Final Draft Report
Expedited System Impact Assessment
Hydro One Networks Inc.
230 kV Circuits L23N, V41N & V43N – Reconfiguration of Phase Positions
CAA ID 2007-EX365

Figure 3 – Proposed Phase Position Reconfiguration on H-frame Structures
(View looking north from Lasalle Road)

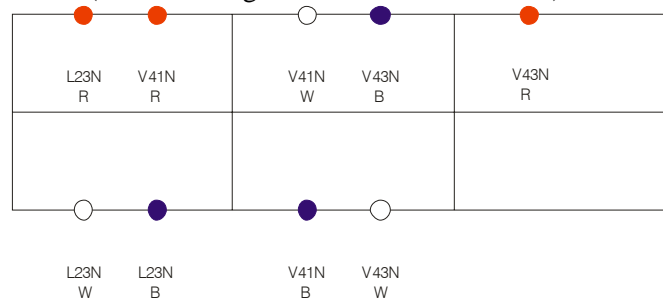
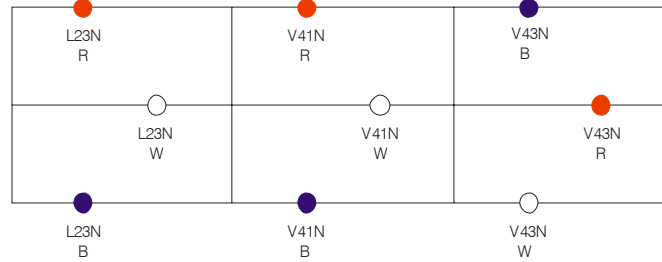
Since L23N and V41N are adjacent to each other and V41N and V43N are adjacent to each other, the IESO-controlled grid is operated by respecting the possibility of a ‘L23N + V41N’ or ‘V41N + V43N’ double circuit contingency.

The proposed reconfiguration will only increase the separation between phase positions and thereby, will not create any new double circuit contingencies. The IESO will continue to monitor and respect the existing ‘L23N + V41N’ and ‘V41N + V43N’ double circuit contingencies.

The proposed reconfiguration of the 230 kV L23N, V41N and V43N phase positions on seven H-frame structures north of Lasalle Road and south of Sarnia Scott TS will not create any new double circuit contingencies that need to be monitored and respected by the IESO.
